# UNITED STATES PATENT AND TRADEMARK OFFICE

APPLICATION NO.	FILING DATE	FIRST NAMED INVENTOR	ATTORNEY DOCKET NO.	CONFIRMATION NO.
10/656,962	09/08/2003	Ching-Fei Chen	1496-916	8819

<b>Office Action Summary</b>	<b>Application No.</b> 10/656,962	<b>Applicant(s)</b> CHEN, CHING-FEI	
	<b>Examiner</b> Noah C. Hawk	<b>Art Unit</b> 3637

### **DETAILED ACTION**

Austin, Figure 1

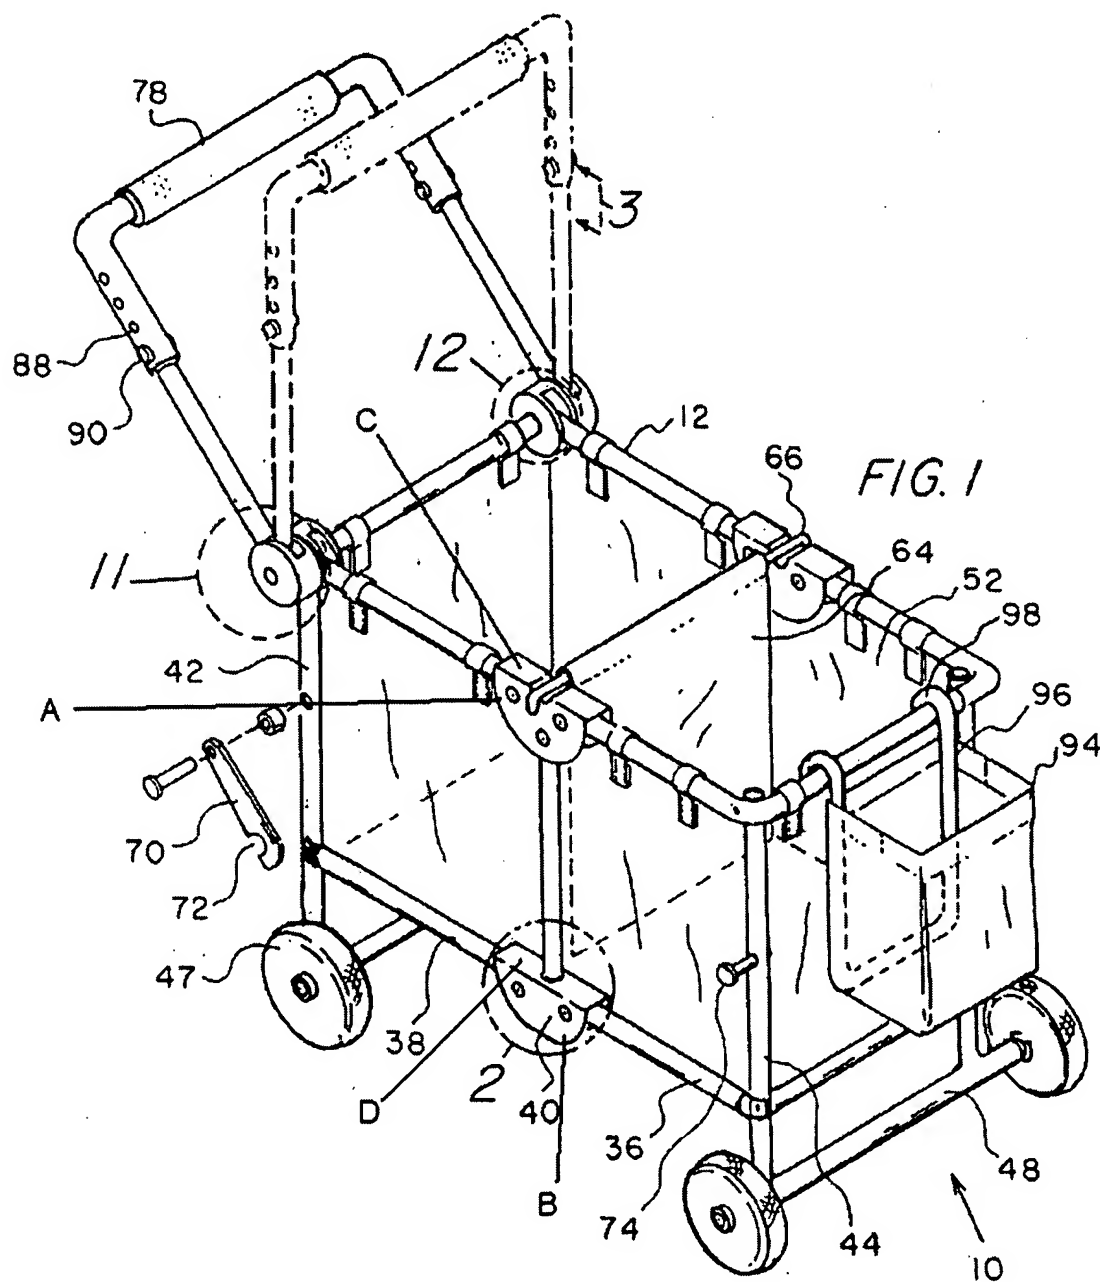
5. Claims 1-3 are rejected under 35 U.S.C. 102(b) as being clearly anticipated by Austin in US Patent 5915723. Austin discloses a foldable framework comprising four upright support rods (42, 44), two upper horizontal rods (14, best seen in Fig. 9) fastened between two of the upright rods, two lower horizontal rods (16, best seen in Fig. 9) fastened between two of the upright rods, and a folding structure at the midpoints of the upper and lower horizontal rods with an upper movable joint (24, best seen in Fig. 7) at the midpoint of the two upper horizontal rods, a lower movable joint (40) at the midpoint of the two lower horizontal rods, and a connection rod (46, best seen in Fig. 2) with a U-shaped upper end (A – the upper movable joint is significantly U-shaped, best

seen in Figure 9), a T-Shaped lower end (B – the lower movable joint projects perpendicularly outward from the lower section of the connection rod and is considered T-shaped), an upper stop portion (C), and a lower stop portion (D).
